LiDAR Quality Assessment Report

Project Type: NSDI Agreement
тојестуре:
Project Description:
Waseca County is one of the 25 counties
as part of the Minnesota River Basin -
Phase 1 lidar project.
Year of Collection: 2010

Lot 23 of 25 lots.

Bare-Earth DEM Anomalies, Errors, Other Issues

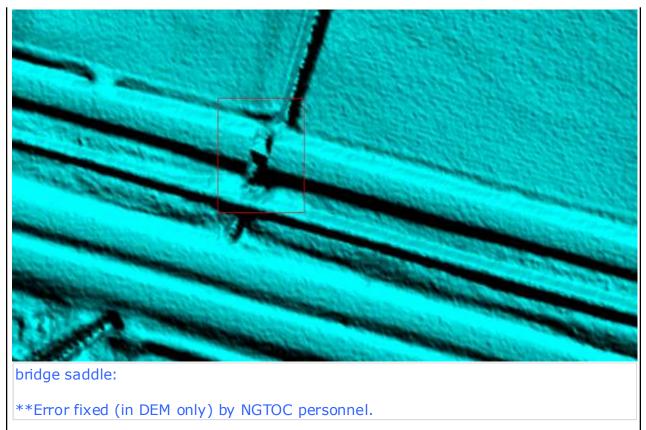
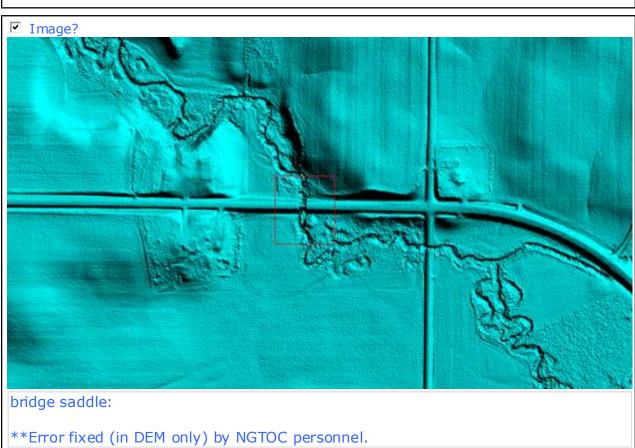
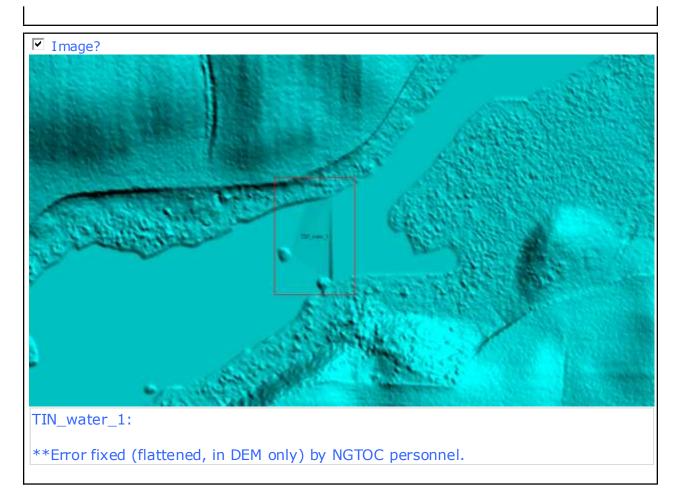
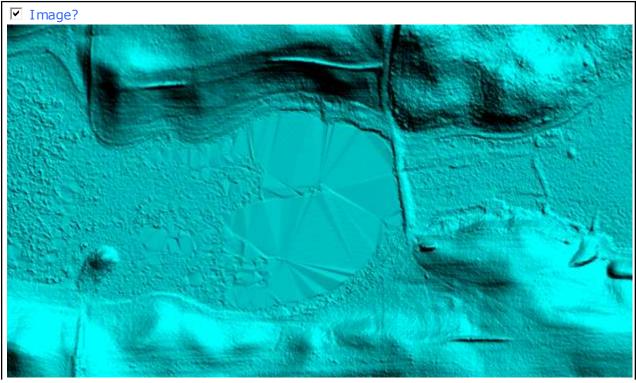
TIN_1: TINing of water body. This is not being called an error.

- A few bridges contained 'saddles' but were smoothed in the DEM.
- A small, TIN'd area within a pond/lake was smoothed in the DEM.
- Portion of water body is TIN'd; not called as an error.
- FVA and CVA were reported in RMSEz.
 - The FVA, reported as 6.7 RMSEz = 13.13 cm Accuracy_z at 95% confidence interval; the NGTOC calculated FVA at the 95% confidence interval is 12.9 cm... which is less than the target 24.5 cm, thus it passes.
 - The CVA reported at 13.6 RMSEz was not reported at the 95th percentile; the NGTOC calculated CVA at the 95th percentile at 22.49 cm...which is less than the target 36.3 cm, thus it passes.
